Draft Requirements for VeraSol Certification of Refrigerators

Stakeholder Feedback

October 2022

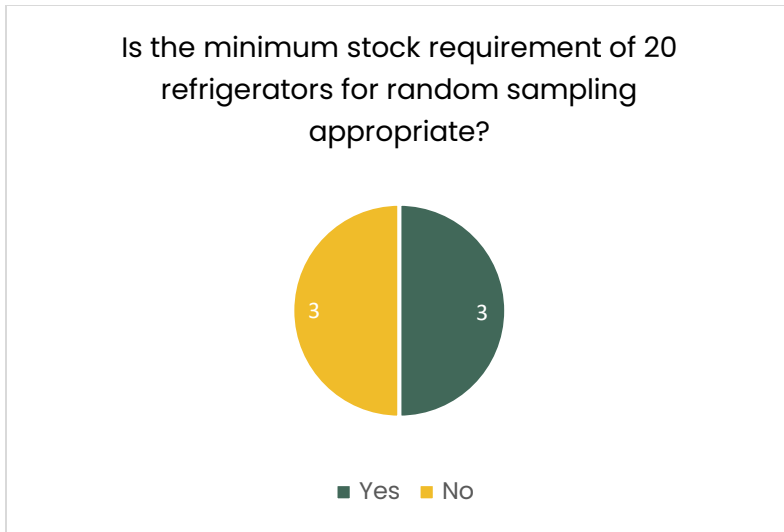
Two pathways are proposed for certifying refrigerators: (1) refrigerators included in an SHS kit and (2) as standalone appliances. Should another pathway be added?

Stakeholder comment	VeraSol response
<p>Fridges without other accessories – vaccine fridges aren't typically provided with solar lighting but are typically offered with solar+battery. However, this might be considered a "SHS kit".</p>	<p>At this time, vaccine storage refrigerators are not considered in the scope of VeraSol certification. We encourage stakeholders to reference the World Health Organization (WHO) Performance, Quality and Safety (PQS) framework for requirements related to vaccine refrigerators.</p> <p>For refrigerators powered by solar and a battery, companies can have their refrigerator certified as an SHS kit where the only appliance in the kit is the refrigerator or as a standalone refrigerator, where the battery, solar module, and associated run-time performance are not assessed.</p> <p>Additionally, based on feedback, we are identifying ways to enable a third certification pathway for solar direct drive (SDD) refrigerators, which typically use a phase change material to store energy instead of a battery.</p>

Run-time requirement

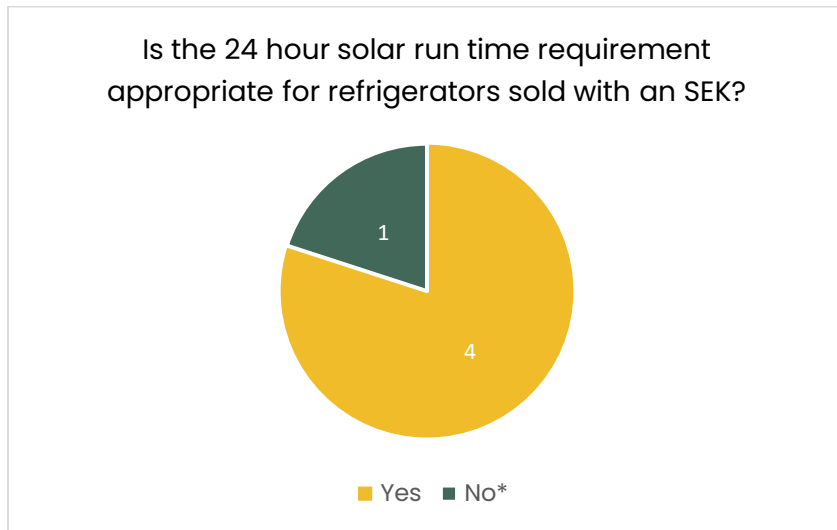
* The one person who answered no stated this because it would not be appropriate for vaccine refrigerators. We will rethink this requirement for SDD refrigerators as we include them in the certification scope.

Scope

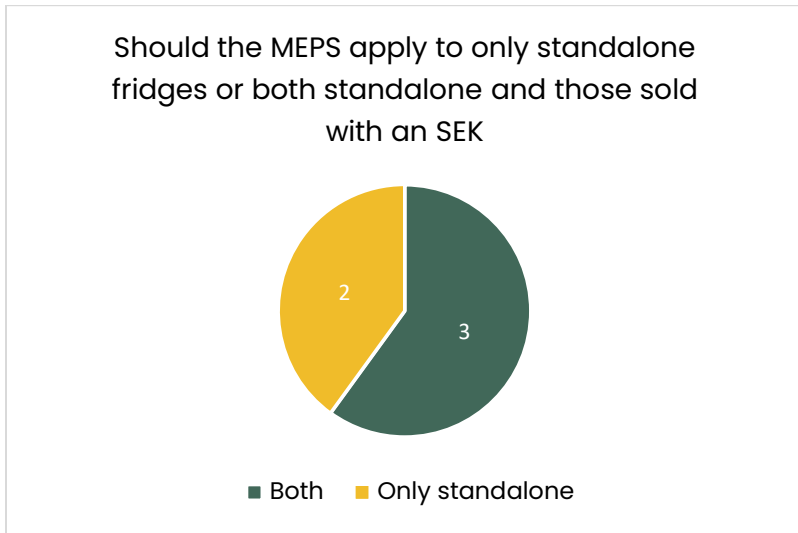
Stakeholder comment	VeraSol response
Voted for MEPS for standalone refrigerators only	
<p>MEPS targets the refrigerator performance, which directly affects the SHS battery and panel sizing. When a refrigerator has low performance, it will need a bigger battery (high cost) and bigger solar panel (high cost); therefore, MEPS directly related to the total cost of ownership (TCO) of the whole refrigeration solution. Once a refrigerator meets a defined target (MEPS), you can set to the market fair TCO - resulting in a better proposition for the end-user. That said, the MEPS works as a tool to address the market's needs for the refrigerator manufacturer/supplier. On the other hand, defining a</p>	<p>We reviewed the responses and determined that it makes the most sense for MEPS to apply to standalone products only. Our testing will ensure that refrigerators sold with an SEK are efficient enough to run with their provided power system. Refrigerators sold with an SEK will also be required to advertise the refrigerator's performance with the SEK, giving customers the choice of which product best meets their needs between metrics such as price, performance, and system size.</p>

<p>MEPS for an SHS kit seems is pointless once the SHS kit supplier is responsible for the whole kit sizing and price selling. They don't need any target (MEPS) to address the markets needs as they are already facing the market pressure to deliver a viable refrigeration solution and a good price point.</p>	
<p>If the supplier chooses to increase the solar system size to suit a slightly less efficient fridge but still meets run time, that should be their commercial decision? Much like the choice of a supplier to choose a lower efficiency LED and increase solar+battery for commercial reasons, there is no minimum lumen efficiency required for SHS kits etc.</p>	
<p>Voted for MEPS for both standalone refrigerators and those sold with an SHS kit</p>	
<p>This guarantees efficiency of the off-grid refrigerators</p>	<p>As highlighted above, we determined that specifying MEPS for refrigerators sold with an SHS kit is redundant, given that efficiency is factored into the design of the SHS as well as VeraSol's SHS runtime requirement.</p>

<p>The energy performance will show the quality of the product, energy efficiency and performances. Hence the need for MEPs for all energy-consuming appliances</p>	
<p>I cannot see any good reason for why they would NOT apply. As appliance performance MEPS should be independent of power source or bundling.</p>
